30
Shearon Harris Nuclear Power Plant
Draft SER Open Item No. 354
NRC Question 210.65

Piping Stress Analysis Data, Allowable Flange Moments

Shearon Harris Nuclear Power Plant
Draft SER Open Item No. 354
NRC Question 210.66

CLIENT CAROLINA POWER & LIGHT CO.
 PROJECT SHEARON HARRIS NUCLEAR POWER PLANT
 SUBJECT THERMAL MODES OF OPERATION - SERVICE WATER SYSTEM

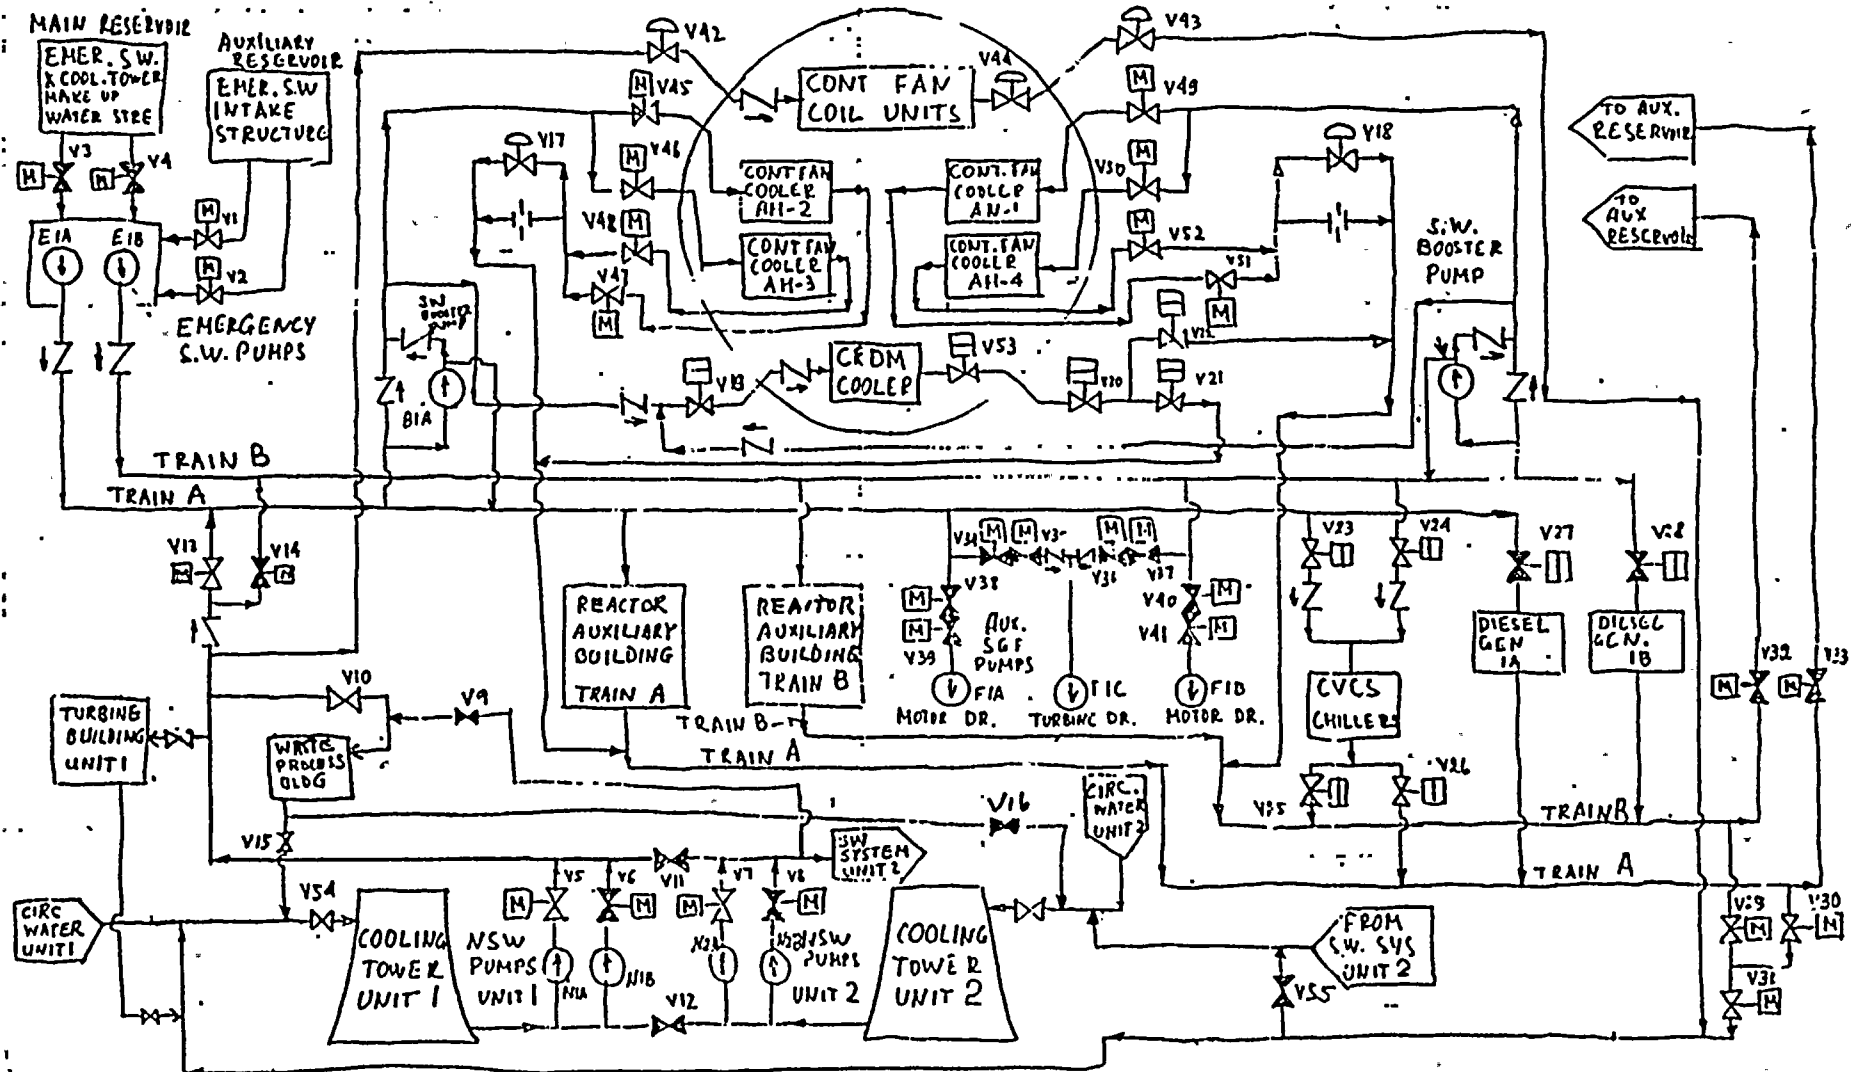
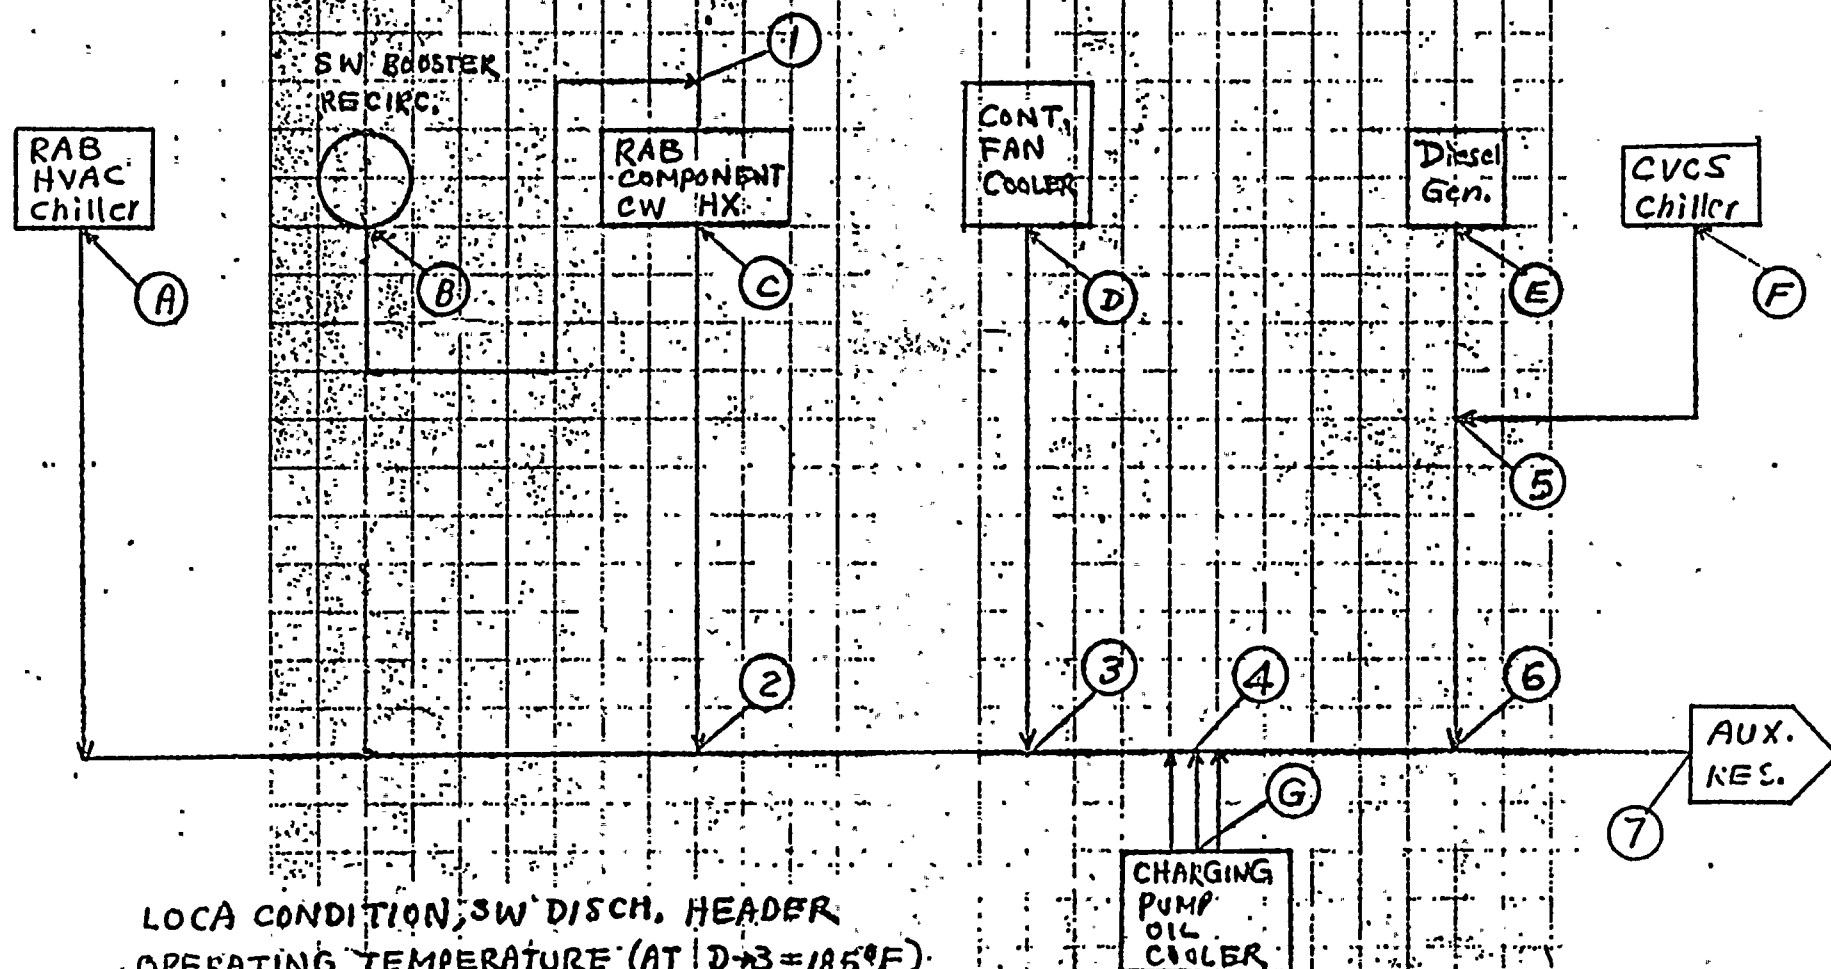
The computer output gives stresses for 11 "Cases." Where does the Specification CAR-SH-M-30, Rev. 16 give the analyst instructions as to which Cases to run and how to evaluate them? See also 0210.47.

Instruction regarding the required Cases and their evaluation is provided in the Ebasco Piping Design Specification, CAR-SH-M-71. See our reply to Question No. 210.59.

Also, please refer to the Attachment for the Thermal Mode Diagram and Thermal Data for the Service Water System. This diagram and the data information are also part of our Piping Design Specification, CAR-SH-M-71.
